SHUDDER ON ACCEL—POSSIBLE WRONG TRANS CROSSMEMBER ASSEMBLY INSTALLED (EXCLUDES GT 500)

TSB 08-23-4

2005-2009 Mustang, Mustang

Figure 1 - Article 08-23-4

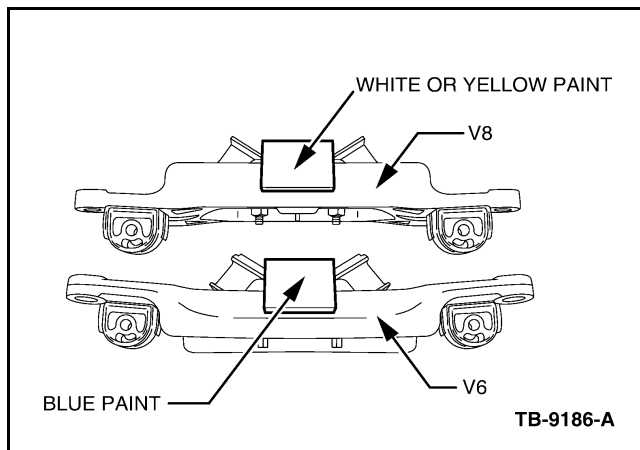
1. Inspect the transmission crossmember assembly orientation. (Figure 1)

- 4.6L V8 vehicles - Transmission crossmember hump should extend upward. Transmission support insulator (trans mount) should have a white or yellow paint dot.

- 4.0L V6 vehicles - Transmission crossmember hump should extend downward. Transmission support insulator (trans mount) should have a blue paint dot.

EXHAUST MOUNTS AND ISOLATORS, SHOWN IN FIGURE 1, WERE PRODUCTION ASSEMBLY AIDS AND ARE NOT REQUIRED. THEY WERE DELETED ON VEHICLES BUILT AFTER 12/03/2007 AND MAY HAVE ALREADY BEEN REMOVED PER TSB 08-3-4.

Figure 2 - Article 08-23-4

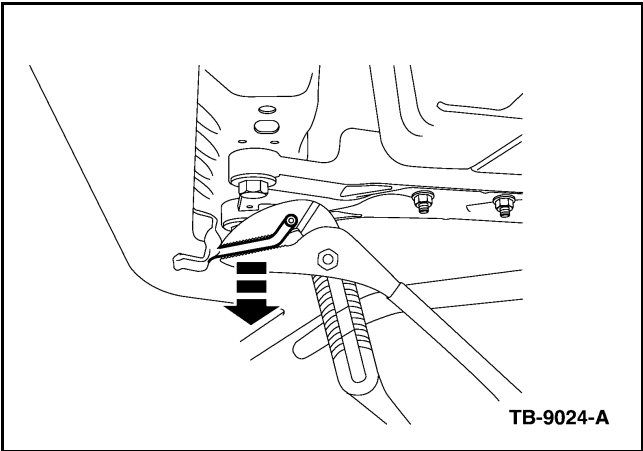
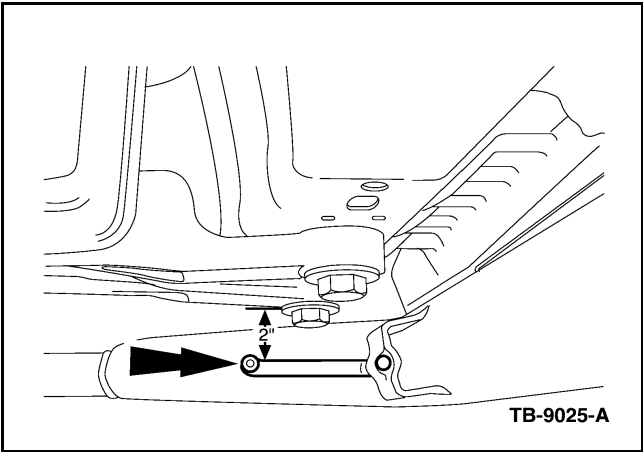
9. Bend exhaust hanger rods to a horizontal position to create approximately 2" (50 mm) clearance to the transmission crossmember. (Figures 2-3)
